SUBJECT: Pilgrim Nuclear Power Station - Information Needs for the Flooding  
Hazard Reevaluation Report; Storm Surge Analysis

Information Needs for the Flooding Hazard Reevaluation Report; Storm Surge Analysis

# Pilgrim Nuclear Power Station (PNPS) Information Needs for the Flood Hazard Reevaluation Report Storm Surge Analysis

**Figure 15 from AREVA, 2015b: PNPS Wave Transects**

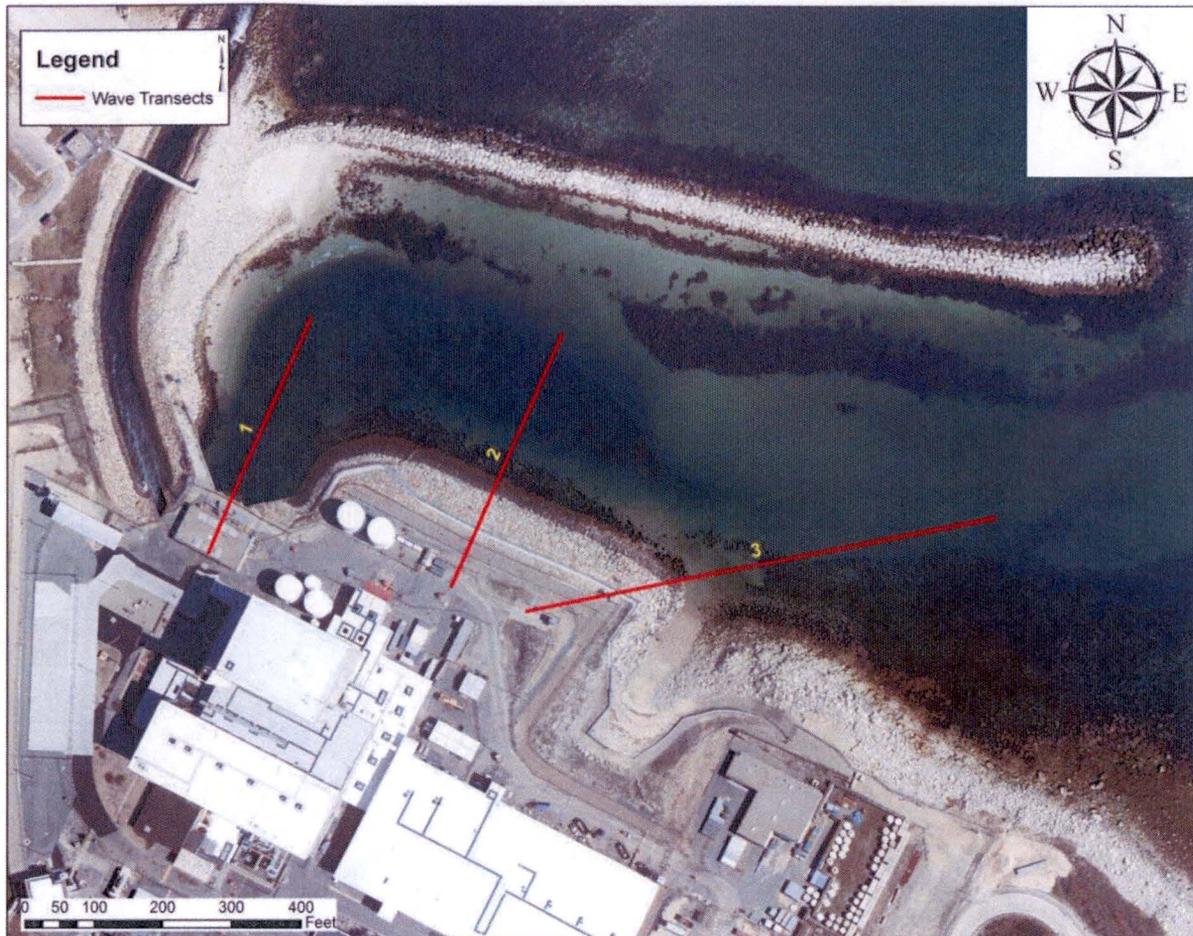
Also, based on Figure 3-46, the staff have noted that westerly directed waves could enter breakwater opening, which could lead to larger wave heights and potentially increased wave runup and total water levels at PNPS.

- a. Discuss how the breakwaters were applied within the SWAN subgrid wave modeling, including if the prior damage to the breakwaters (winter storms of 1977-1978 and 1978-1979) was considered and included in the model setup. If the breakwaters were

considered as fixed and robust structures within the SWAN subgrid wave modeling, discuss the implications of how damage to the breakwaters during actual storms may increase the wave energy that reaches the revetment near PNPS and total water level near the PNPS infrastructure.

To assess these potential effects, a sensitivity analysis was performed using the nearshore SWAN model. Damage estimates, in the form of percent reductions to the top elevation of the main breakwater, were developed based on the Hudson formula, which is commonly applied in designing breakwaters and/or assessing damaging wave conditions (USACE, 1995). **Appendix C** details calculations that produced estimated potential percent damages of approximately 9% during the PMH and approximately 18% during the PMWS based on maximum simulated significant wave heights during each event. Based on the PMWS damage estimate, a variation of the original SWAN model bathymetry was designed to conservatively reflect a reduction of 20% to the top elevation of the main breakwater at the outset of simulated time (i.e., the model bathymetry is modified prior to PMH or PMWS occurrence). Simulations, subject to a number of conservative assumptions (i.e., as described below), were then performed using the nearshore SWAN model reflective of the reduced breakwater elevation for the PMH and PMWS cases. Wave characteristics were then extracted and used to estimate wave runup elevations and maximum water surface elevations for the transects shown in the following figure under each simulated condition:

The resulting wave effect calculations are summarized below for Transects 1, 2, and 3, respectively. It is important to note that the values presented in these tables represent final re-evaluated total water surface or adjusted wave runup elevations that include consideration of storm-induced surge, wave setup, and wave runup. Furthermore, it is important to note that the simulated damage scenario is considered to be a very conservative representation of maximum potential damage to the main breakwater, as the damage estimate was based on several conservative assumptions including, but not limited to, the following:

As indicated by the information provided above, the conservative breakwater damage scenario assessed as part of the sensitivity analysis did not result in a total water surface elevation above 21.5 ft MSL at the PNPS intake or a wave runup condition exceeding an elevation of 23.0 ft MSL, the critical elevation.

Figure 3.9-11 from AREVA, 2015b: Peak Significant Wave Height - PMH

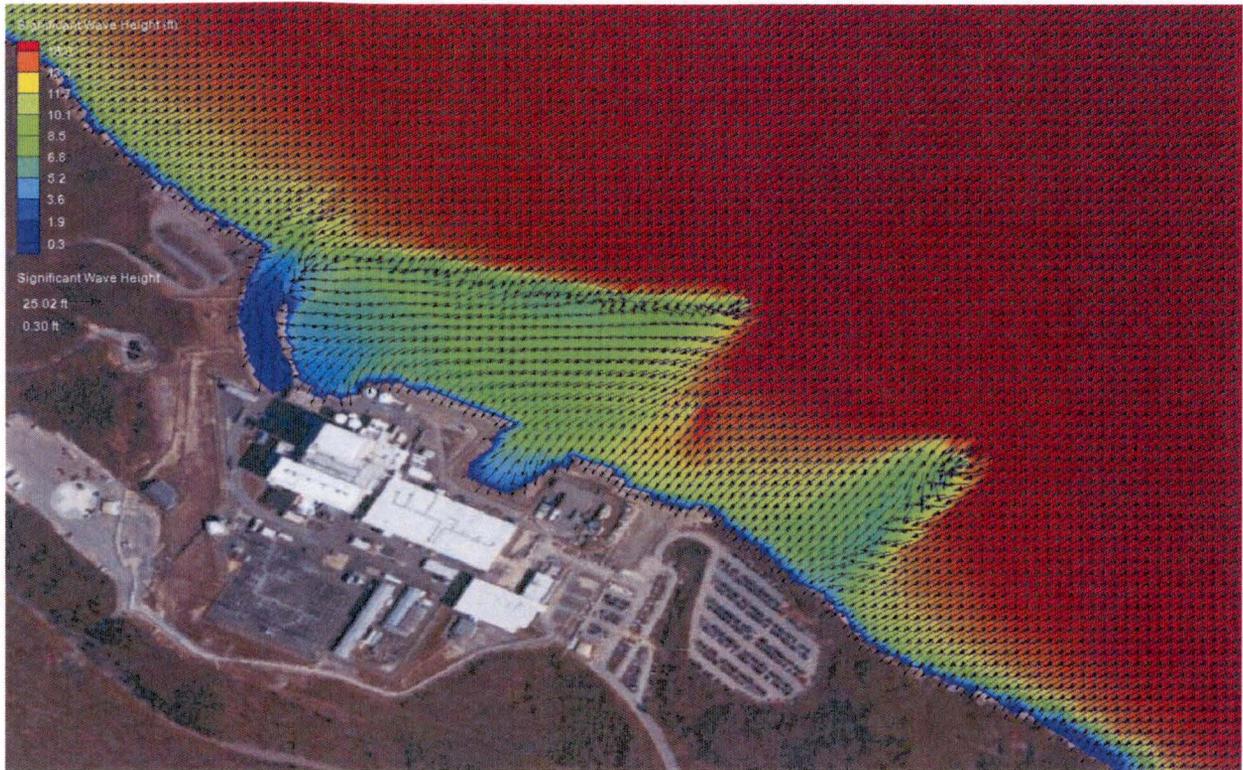
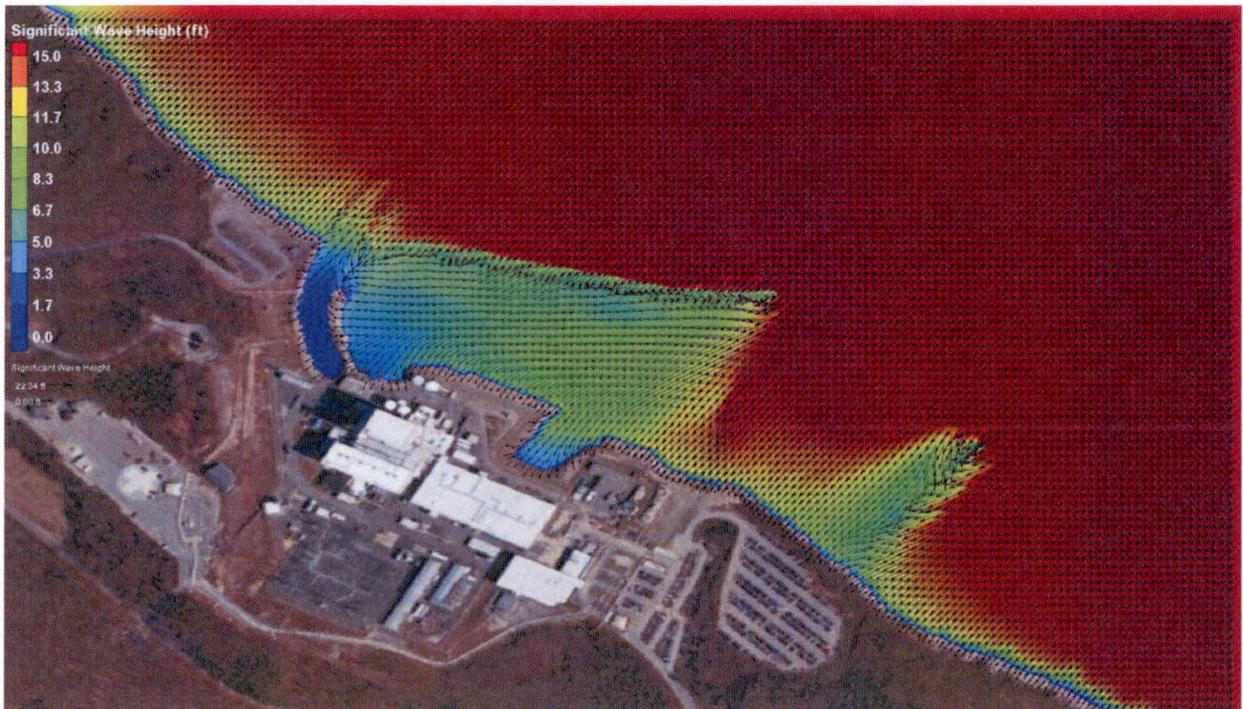
- b. Discuss if any PMH simulations resulted in more westerly-directed waves that produced larger wave heights propagating through the breakwater opening and impacting the PNPS revetment.

A detailed analysis focusing on optimally aligning wave approach angles with the breakwater opening was not specifically performed in support of the FHRR; however, as indicated by Figures 3.9-11 and 3.9-12 from the PNPS FHRR, which are reproduced below, wave directions associated with peak wave conditions occurring during the PMH and PMWS are aligned with the opening of the breakwater pairing at PNPS. Thus, wave conditions (i.e., wave height and period) used to perform runup calculations do consider some bypassing behavior. While these figures clearly show peak wave conditions striking the shoreline at oblique angles, runup calculations were performed assuming head-on wave alignment. This very conservative assumption maximizes runup at all assessed locations above the maximum predicted stillwater elevations generated by the PMH and PMWS, respectively. This conservative approach would offset any slight increase in wave conditions resulting from storm alignment modification, which would also result in a reduced stillwater elevation relative to the PMH or PMWS.

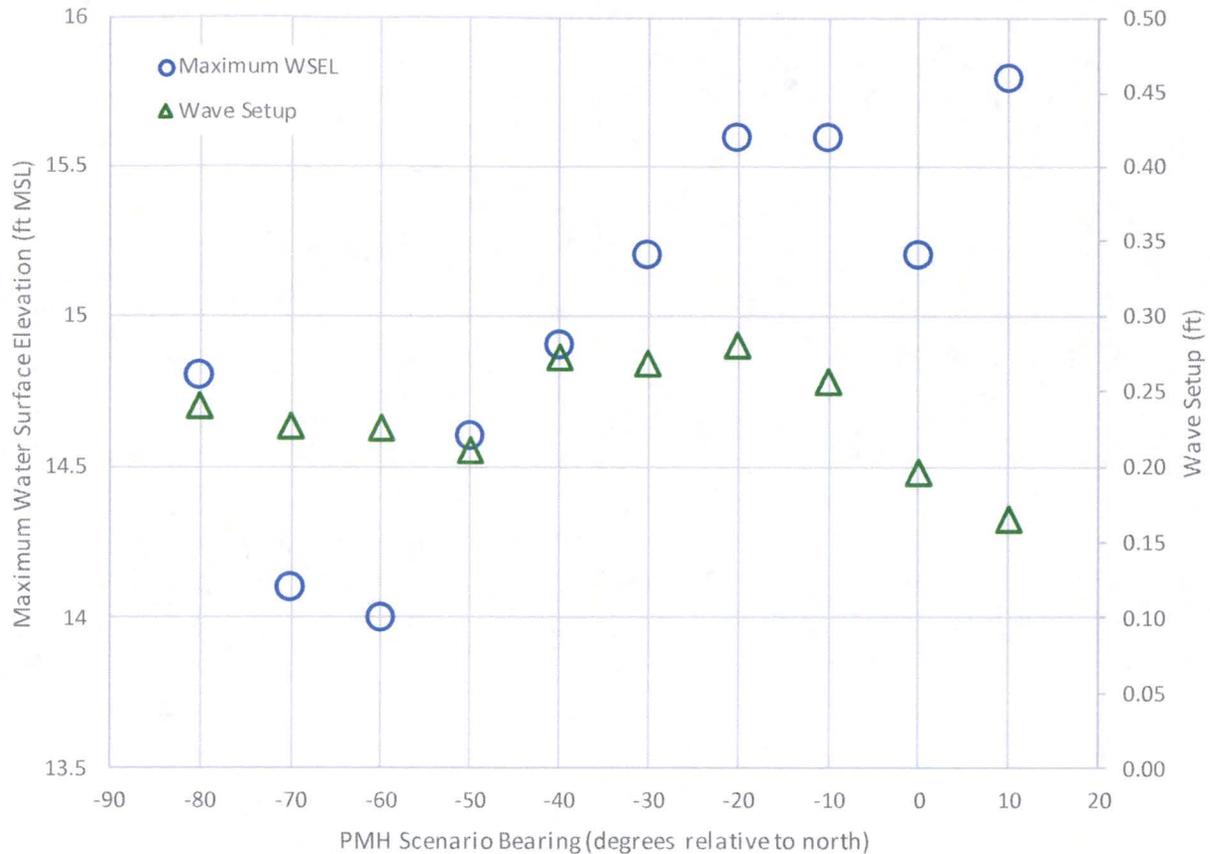
**Request:** Discuss any FHRR PMH candidate simulations that resulted in larger wave setup values than the PMH storm results in Table 3-8. Discuss the high-resolution nearshore wave modeling (FHRR Section 3.9) and the estimates of wave setup near PNPS using this model. Also, discuss the effects of larger wave setup on the wave runup and the total water surface elevation at PNPS site.

The influence of wave setup on maximum stillwater elevations at PNPS was initially assessed using the difference between PMH candidate simulations performed using ADCIRC and SWAN+ADCIRC (i.e., the former excluding wave setup in maximum stillwater elevation output, and the latter including wave setup in maximum stillwater elevation output). As shown in the figure below, the controlling PMH scenario (i.e., STORMID 3397 at a bearing of 10 degrees) resulted in the maximum stillwater condition with only a slight difference in wave setup magnitude relative to the other PMH candidates. In agreement with the statement presented above, wave setup magnitude was determined to be increasing slightly in simulations associated with PMH candidates moving more west-of-north; however, maximum stillwater elevation, which included wave setup via SWAN+ADCIRC, was selected as the governing criterion for identifying the PMH subject to site-scale runup calculations.

In consideration of the similar wave conditions generated by the SWAN+ADCIRC model and the nearshore SWAN model, as well as the fact that initial water level conditions specified in the nearshore SWAN model were set equal to the maximum PMH/PMWS stillwater elevations outputted by the SWAN+ADCIRC model (i.e., therefore already inclusive of a measure of wave setup), it is reasonable to conclude that wave setup contributions have been conservatively considered in determining maximum flooding elevations at PNPS.

**Figure 1 from AREVA, 2015a: Scatter plots of the hurricane parameter pairs: rmwx-fdir (panel a), rmwx-fspd (panel b) and fdir-fspd (panel c). Gray dots include all data within the HURDAT domain. Large blue dots are from PNPS data. The red line is a linear regression line through all data.**

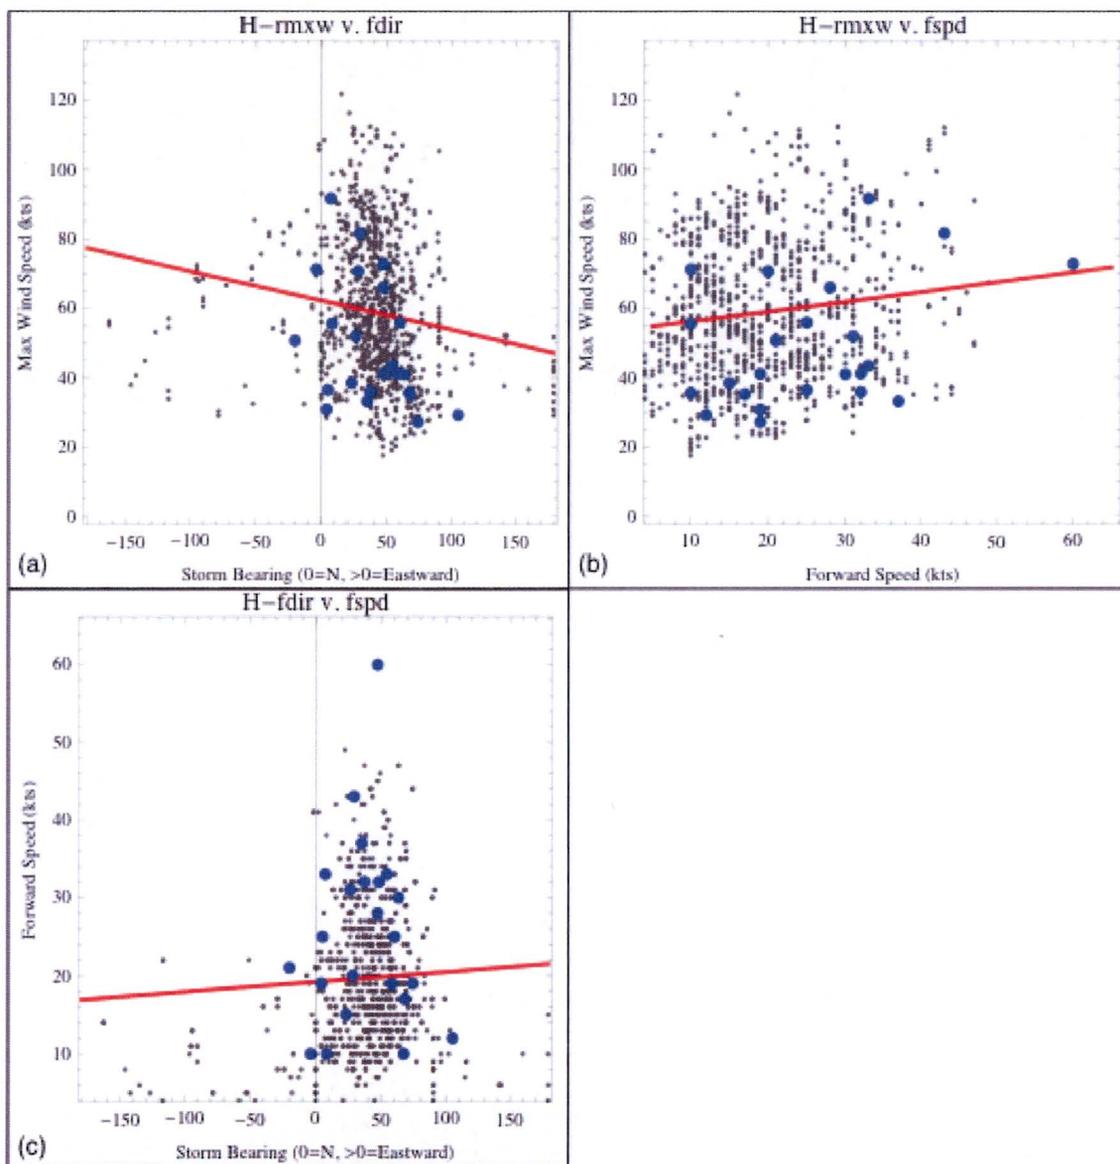
Request: Provide additional justification that the FHRR's lower central pressure values at more westward motions adequately define the PMH for the degree of storm intensity.

In each panel of Figure 1 from the PMH calculation (AREVA, 2015a), which is reproduced below, HURDAT2 data for the PNPS subregion are shown as large blue dots, while HURDAT2 data from 12 other subregions extending to the east, west, and south are displayed in small gray dots. A linear regression line based on all plotted data is shown for each parameter pair as a red line. Note that rmwx is maximum wind speed, fdir is storm bearing, and fspd is storm forward/translational speed.

Panel (a) from Figure 34 shows that the strongest storms move in a north/northeast direction, with infrequent, lower intensity storms moving in other directions including west-of-north. It is important to note that the number of storms moving west-of-north does not rapidly decrease as bearing angle decreases.
